HN-123

# **TECHNICAL BULLETIN**

### INSTALLATION -- TAIL ROTOR PITCH CONTROL LINKS PN 369A1807-5

#### Figure 1. Replacement - Tail Rotor Link Assemblies

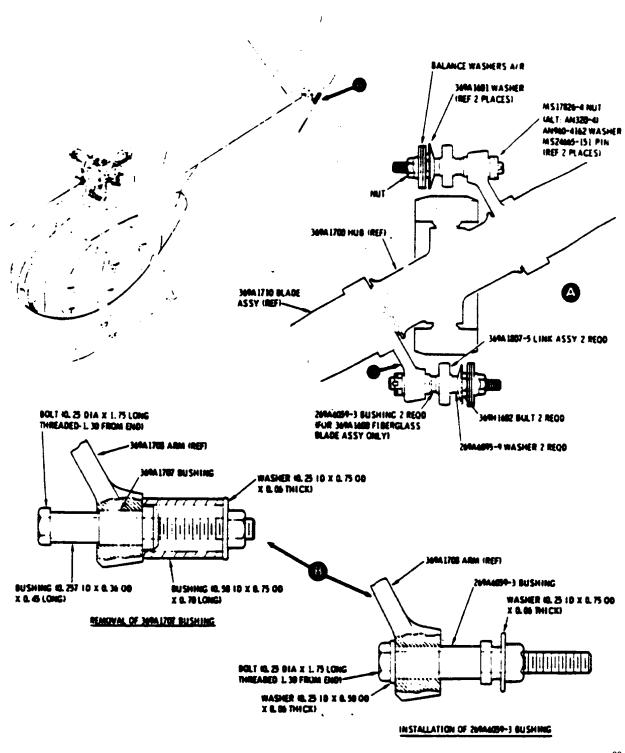
The information given in this Service Information Notice lists a procedure for removal of existing PN 369A1807 tail rotor pitch control links where installed on the above affected helicopters, and replacement with new PN 369A1807-5 pitch control link assemblies. The new -5 links incorporate new type bearings which provide increased angular throw between the link and swashplate, and the link and blade control arm, when blades are in high pitch angles.

It is to be noted that, for PN 369A1500 Series fiberglass tail rotor blade assemblies only, instructions are also provided for replacement of the blade control arm bushing, to accommodate the new -5 pitch control link assemblies.

- (1). Remove tail rotor assembly, per Basic HMI.
- (2). Disconnect ends of pitch control links at swashplate and at pitch control arms. Identify and retain dished washers for reinstallation in original location.
- **NOTE:** Replacement of bushing in pitch control arms per step 3. below not required for 369A1620 aluminum rotor blade assembly.
  - (3). Replace existing 369A1707 bushing in each pitch control as follows:
    - (a). Assemble bolt. bushings, washer and nut on pitch control arm as shown in Figure 1; tighten bolt to remove 369A1707 bushing
    - (b). Assemble bolt, washer, new 269A6059-3 bushing, washer and nut, as shown in Figure 1; tighten nut to seat bushing in arm. Install bushing with wet zinc chromate primer.

- (4). Install new 369A1807-5 link assembly between tugs of swashplate..
- (5). Install bolt, two washers and nut; torque nut to 50 to 80 inch-pounds anti install new cotter pin.

- (6). Pull pitch control assembly inboard or outboard as required to align pitch control link bearing with pitch control arm bushing.
- (7). Place existing spring tension washer on bolt so that concave (dished) surface is against bolt head; install new 269A6095-9 washer on bolt and insert bolt through bearing of pitch control link and bushing in pitch control arm.

- (8). Install washer and nut.
- (9). Torque nut to 50 to 80 inch-pounds and install new cotter pin.
- (10). Repeat steps 4 through 9 for remaining link assembly.
